# Service Bulletin

Bulletin No.: 19-NA-220

**Subject: Loss of Propulsion, Malfunction Indicator Lamp (MIL) Illuminated - DTC P0A3F and/or P1B03 Set**

**This bulletin replaces PIP5641D. Please discard PIP5641D.**

5518453

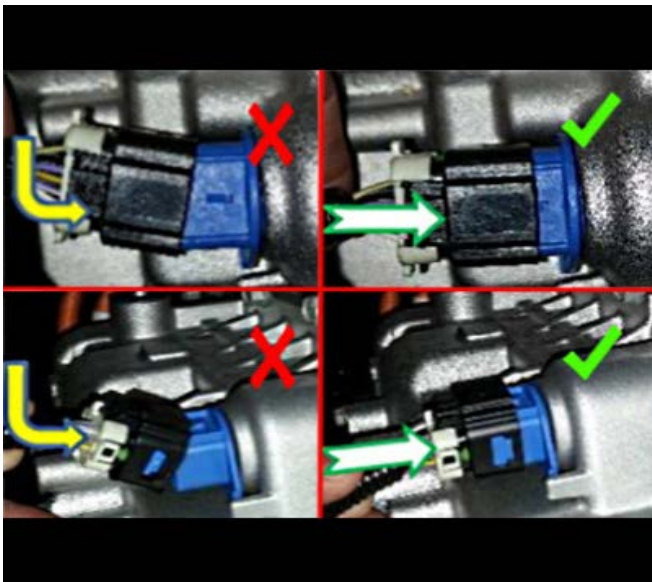
Ensure that the connector is fully seated.
